**Historical Architectural Review Board
COA Preliminary Review Sheet**

HDC-2024-00046

Address: 620 N 6th Street

Proposal: Replacement of three aluminum windows. (Violation Correction)

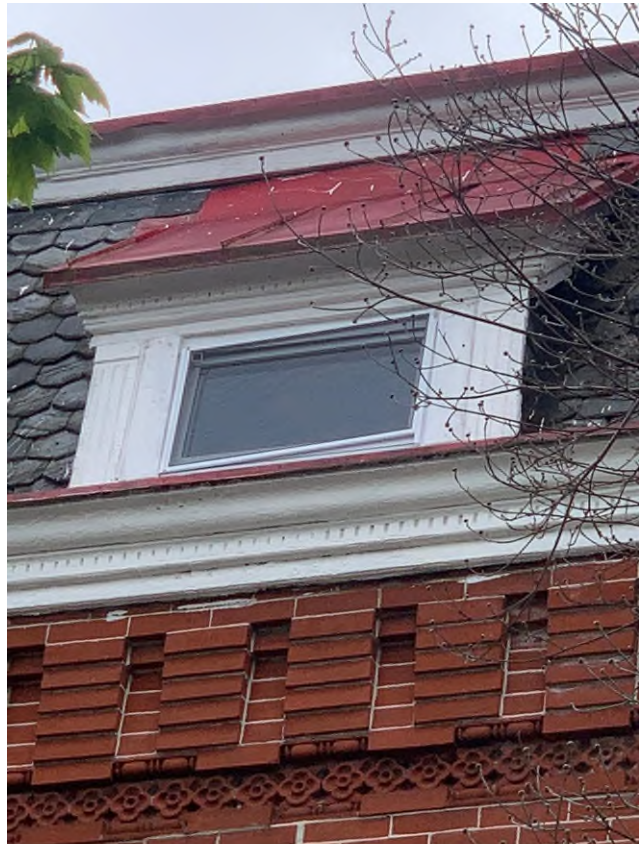
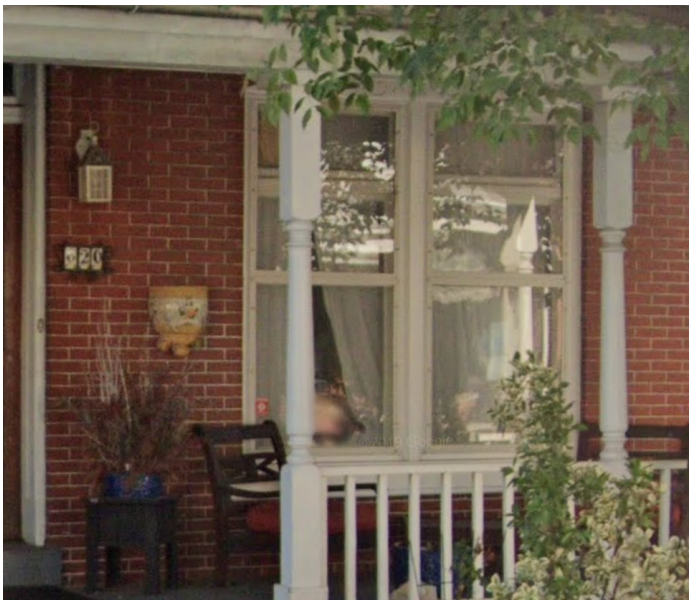
Observations & Comments: The installed replacement windows do not reflect the historic detailing and material, and are therefore not appropriate. It would be helpful if the owner/applicant can provide photos of the windows beforehand, or evidence that they needed to be replaced rather than repaired. It appears that the upper story window did have special detailing that was not replicated and should have been. The first floor windows appeared to be fixed windows with a transom above and exterior storm windows, and the installed replacements are 1/1 sash windows with no transoms. Staff request clarification on the material of the window construction. The application indicates the windows were replaced with "aluminum." Unlike aluminum clad wood, aluminum-only is not acceptable, as aluminum-only windows cannot replicate the detailing of muntins and trim.

Discussion: The applicant is looking for a solution for what they need to do to resolve this. Ms. Baade asked the applicant to clarify what the material of the windows is; the applicant noted to review the provided photographs. Mr. Jordan noted that the applicant should review Section 3.5 of the Guidelines for the evidence required for window replacement. Mr. Jones noted he provided the pertinent sections of the guidelines to review. The applicant asked who he could contact to assist; Mr. Jordan noted that the board could not provide specific contractor information, but a letter from any licensed contractor could be provided to indicate the need for repair. Mr. Jordan also noted the window will need to be re-built to match the previous windows. The applicant noted he does not know any contractors that can assist. Mr. Jordan noted there is a timeline required to review, so he believes the board may need to deny the application. Mr. Jordan noted the board does not have the ability to table the application again given the timeline requirements. In the meantime, it was recommended the applicant look for a contractor that will be able to perform this work. The applicant noted concern that he has replaced the windows and does not know where he'd find the materials to match the original windows.

Staff Recommendation: It is recommended to deny the application.

Action: Mr. Jordan made a motion to deny the application presented on August 5, 2024 for the replace of windows at 620 N 6th Street because it did not comply with the Guidelines for Historic Districts: Chapter 3, Section 3.5 – Windows and there were no known unique circumstances that would apply.
